MIL-H-44117A

AMENDMENT-1

6 March 1990

HELMET, COMBAT VEHICLE CREWMAN, BALLISTIC SHELL, DH-132A

FIGURE 1. FRAGMENT SIMULATOR CALIBER .22, TYPE 2 (BODY ARMOR)

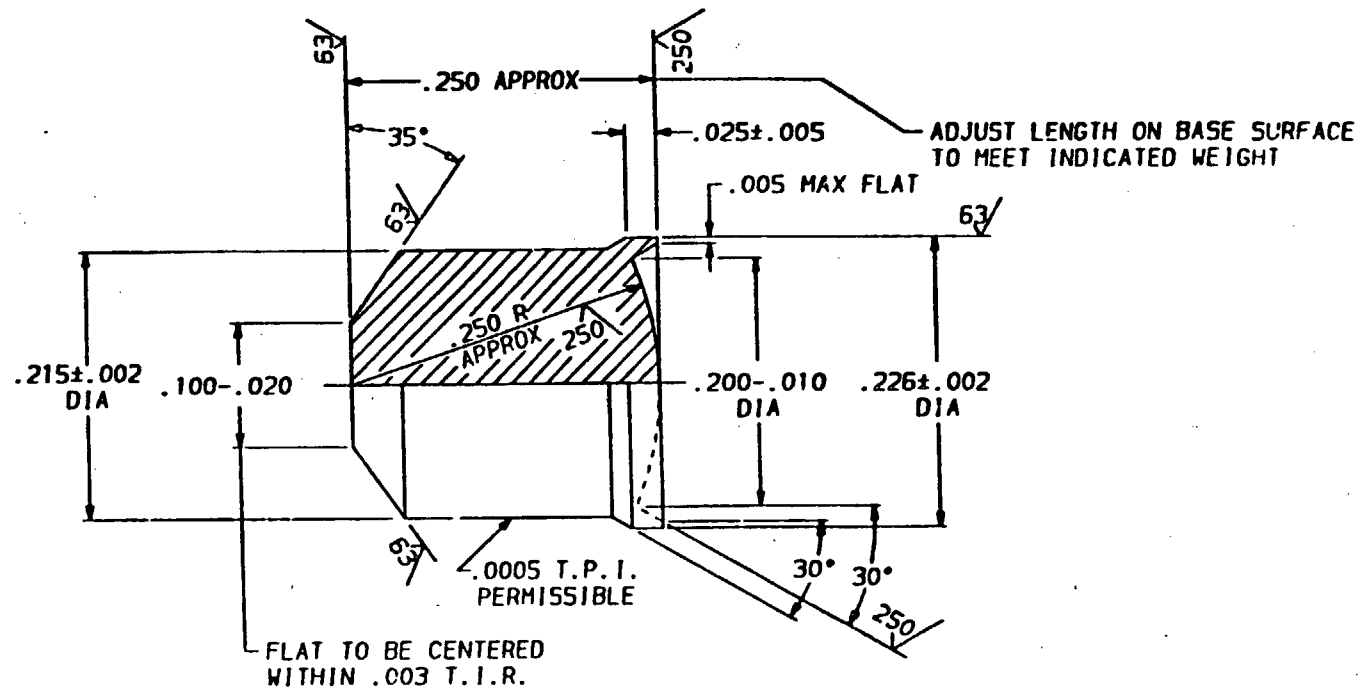
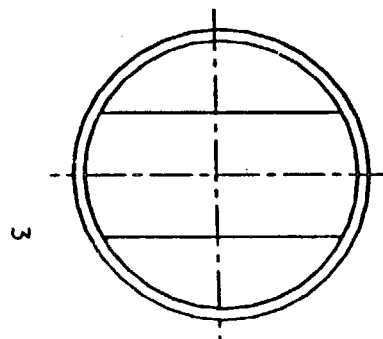
Figure 1: Delete and substitute the attached "Figure 1":
